Cotton Club (BD) Ltd. (Extension - 3)

Jarun (South), Kashimpur, Gazipur.

30 December 2025

2. Observation

Observation-01: Significant deviation between as-built condition and approved layout from local authority. (Building-10A)

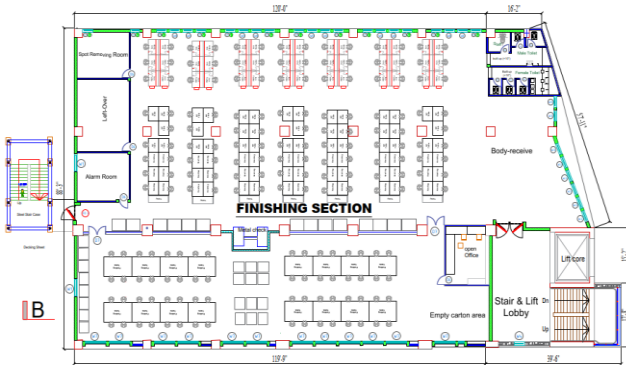
As-Built Layout

Local Authority Approved Layout

Beam-slab re-bar kept exposed for future horizontal expansion

Description: During the inspection, deviations were observed between the as-built condition and the local authority approved layout of Building-10A, including changes in layout, floor area, storey (in proposed drawing) stair and lift core positions.

The building construction was started in August 2022. The approved layout was not followed and revised approval for the modified layout was missing. Also, there is possibility for horizontal expansion toward the west side; exposed beam-slab re-bar was also observed.

The building engineer is required to evaluate the building assessment following BNBC 2020 and prepare Engineering Assessment (EA) and obtain revised approval for the modified layout from the respective local authority.

In the construction drawing, $f'_c = 3500$ psi (27.58 MPa) and $f_y = 60000$ psi (B420DWR)

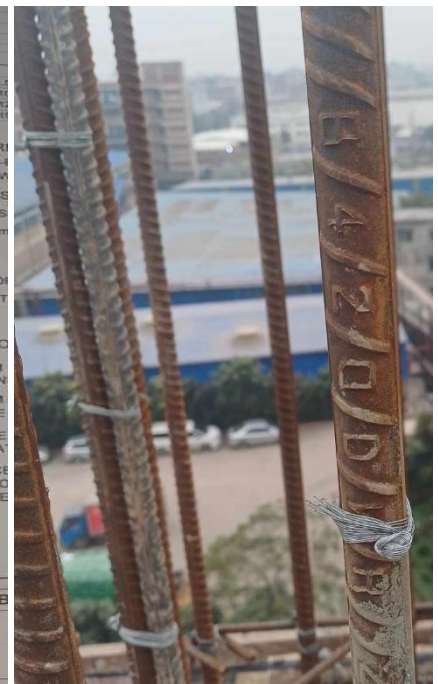
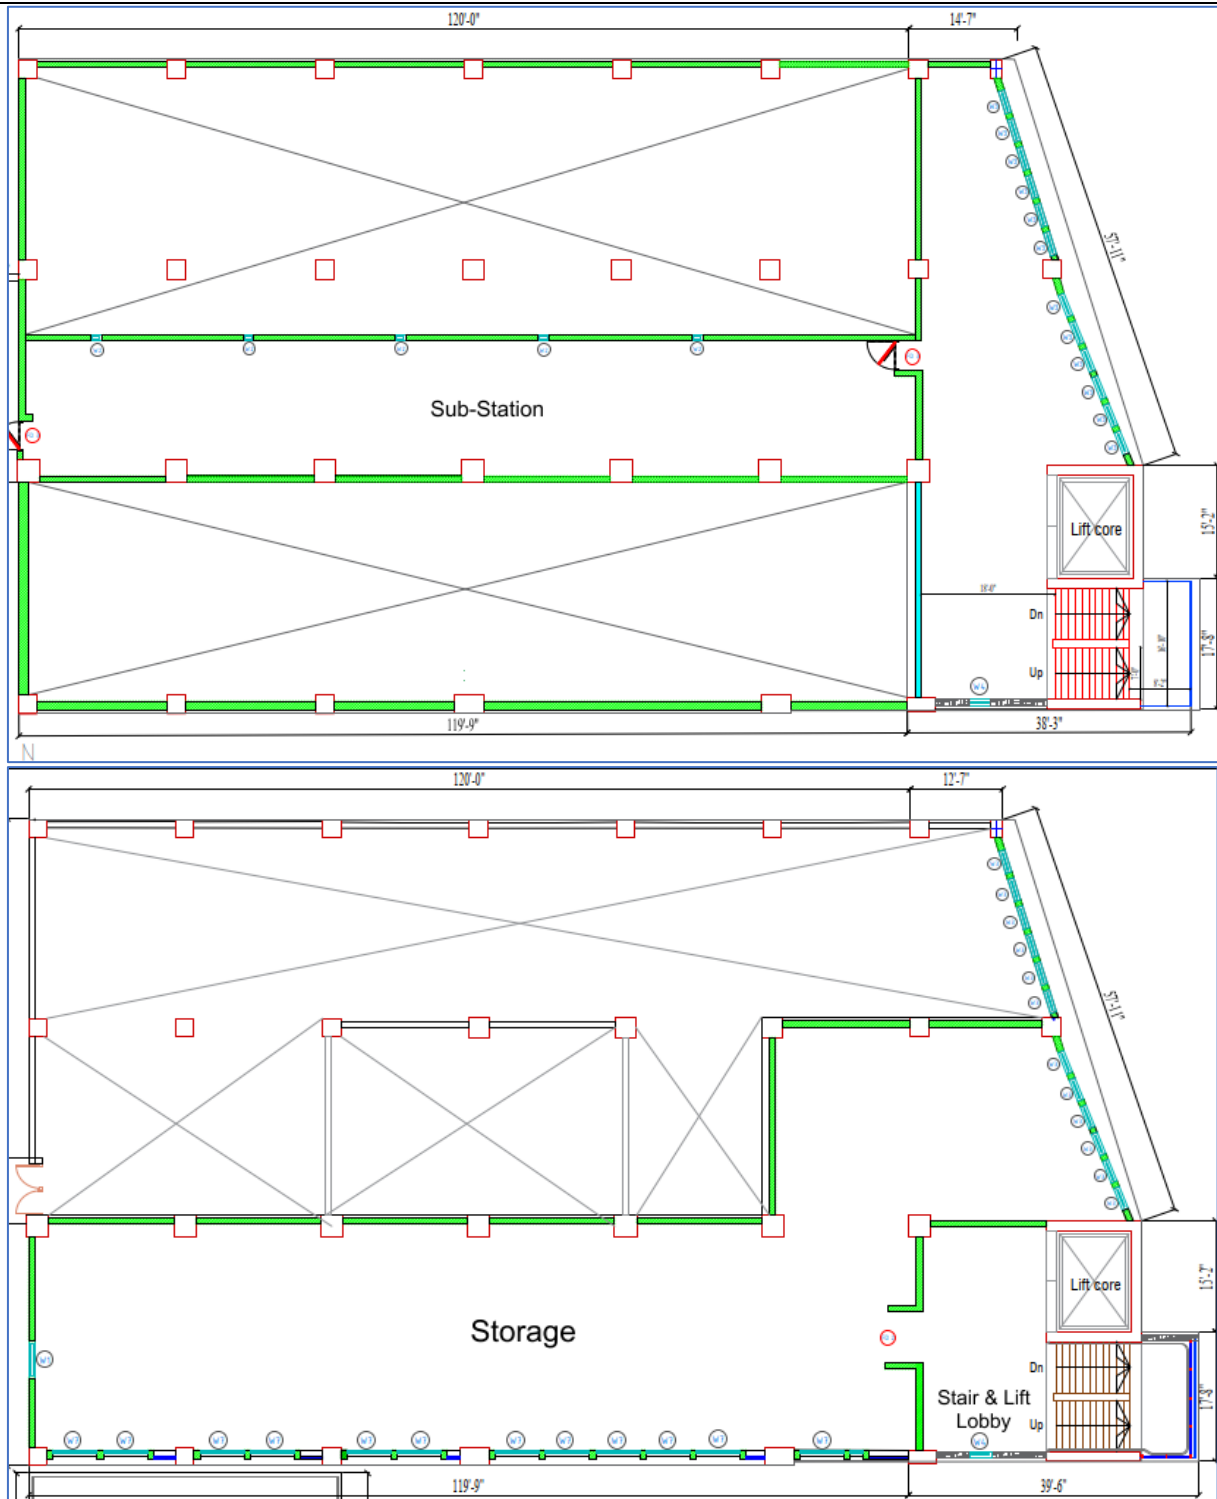
In the EA report, $f'_c = 3500$ psi (24.13 MPa), $f_y = 72,500$ psi (500 MPa); re-bar test report for 500 MPa

Description: Different material strength considered in EA report and construction drawing for the concrete and re-bar. The building engineer is required to consider uniform material strength as per the site condition and actual test report.

In the EA report, pile capacity = 170 kip (756 kN) with FoS 2.5 for 24.4m long pile

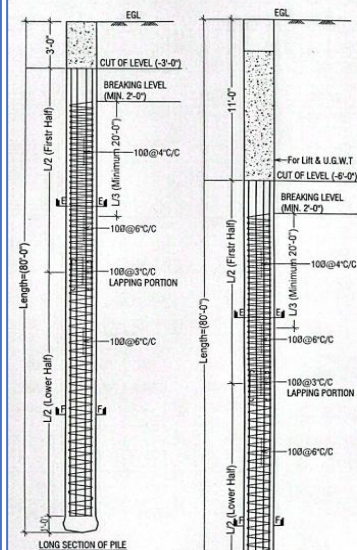
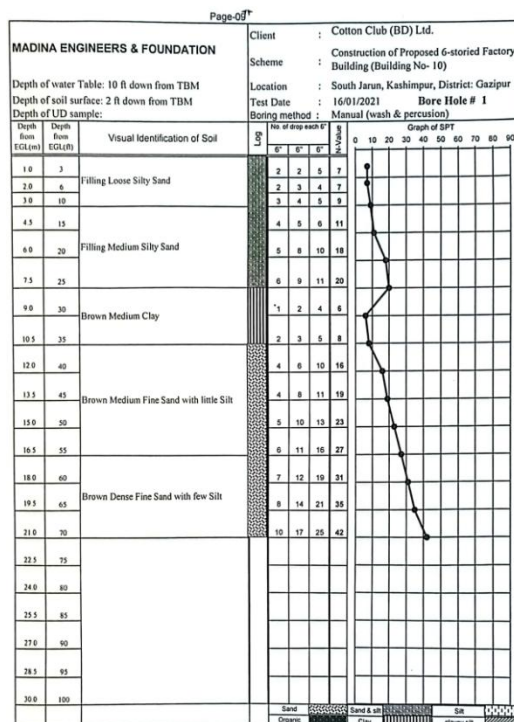
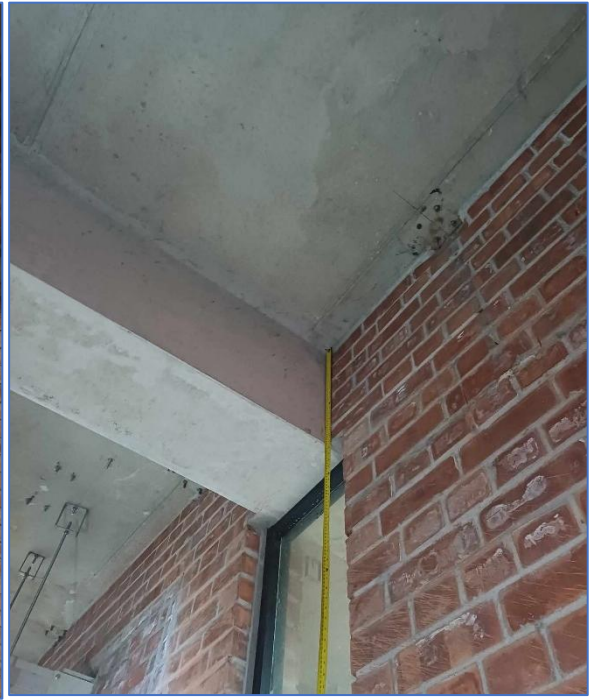
Pile bearing capacity was not incorporated in geotechnical investigation report. Bore hole depth 21m.

Description: The pile bearing capacity was not incorporated in geotechnical investigation report. Also, bore hole depth is 21m and there is no soil data at the pile depth at 24.4m. The building engineer is required to add necessary calculations in the EA report to confirm the pile capacity.

Observation-03: Discrepancy in the provided drawing. (Building-10A)

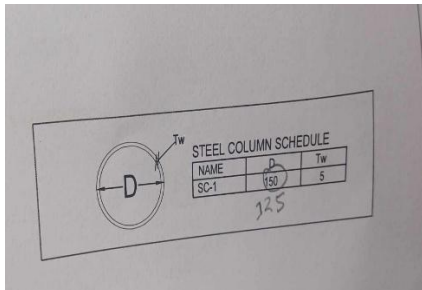
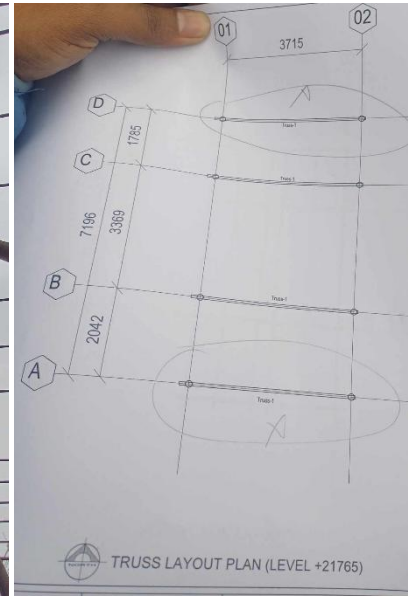
1st floor height found additional +150mm and all beam depth found additional 25mm

External Steel Stair mismatches: steel column size, connection bolt diameter and number, connection type, roof truss missing, bracing missing at 4th and 5th floor level

Description: During the inspection, mismatches were observed between the provided drawing and actual site condition. The building engineer is required to update the as-built drawing reflecting actual site condition and submit to RSC for detailed review.

In the EA report, plie capacity = 240 kip (1067 kN) with FoS 2.5 for 30m long pile

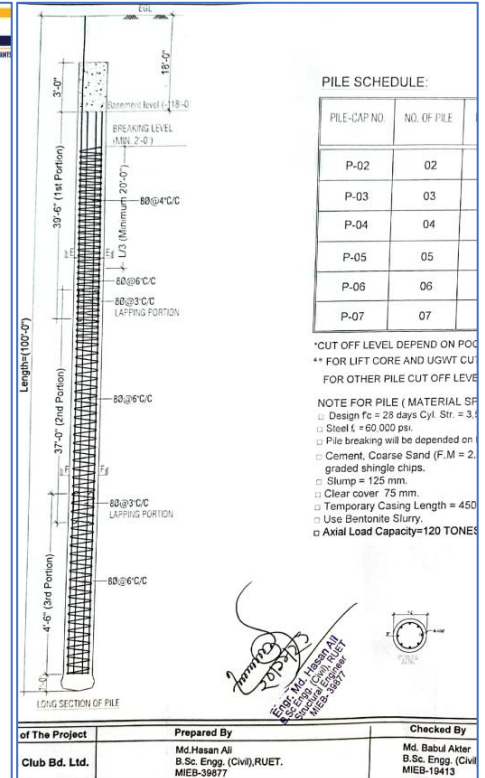
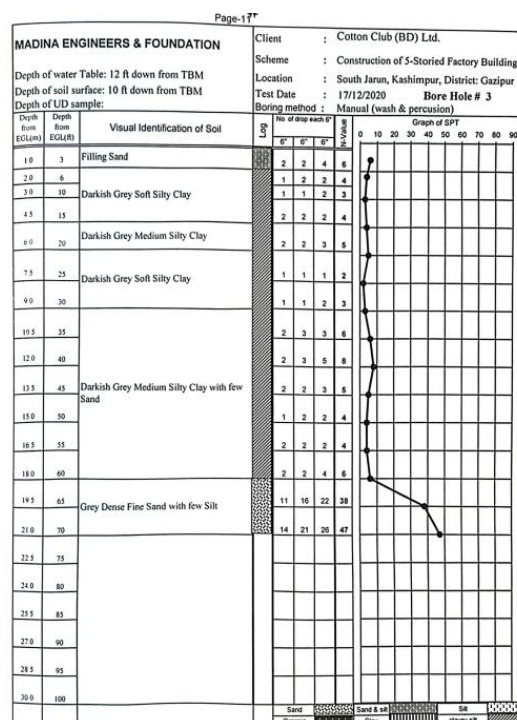
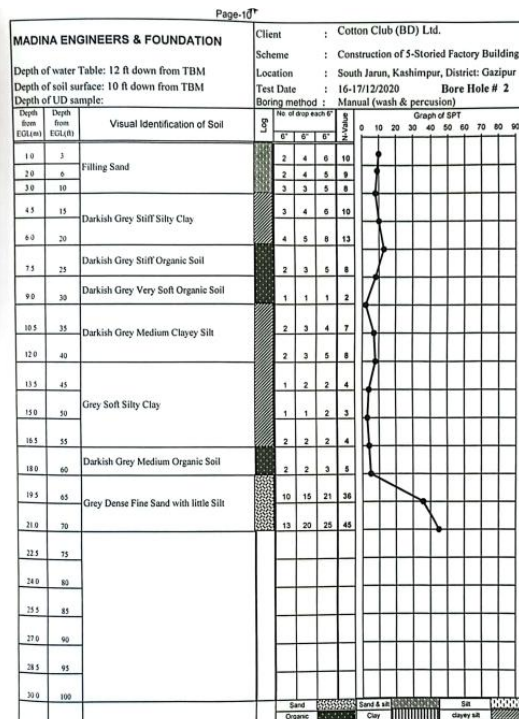
Pile bearing capacity was not incorporated in geotechnical investigation report. Bore hole depth 21m.

Description: The pile bearing capacity was not incorporated in geotechnical investigation report. Also, bore hole depth is 21m and there is no soil data at the pile depth at 30m. The building engineer is required to add necessary calculations in the EA report to confirm the pile capacity.

Observation-09: Material strength test report does not comply with the BNBC criteria. (Building-15)

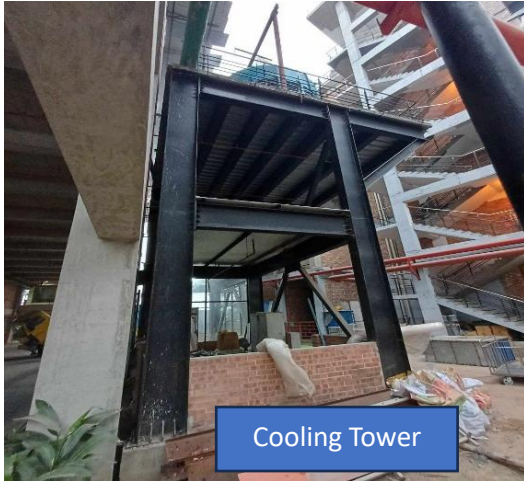
Description: The concrete design strength was considered 4500 psi (31 MPa) for all class (foundation, column, beam, wall etc). For foundation, 11 no's cylinder test reports were available, of which 6 test results did not achieve the specified design strength. For column concrete, 19 no's cylinder test reports were available, where 1 test report result did not achieve the specified design strength. Which indicates that the acceptance criteria of BNBC 2020 Part-VI Section 5.12.3.3 are not satisfied.

Verify in-situ concrete strength by taking 4-100 mm diameter cores from the structural elements (mat foundation, column, shear wall).
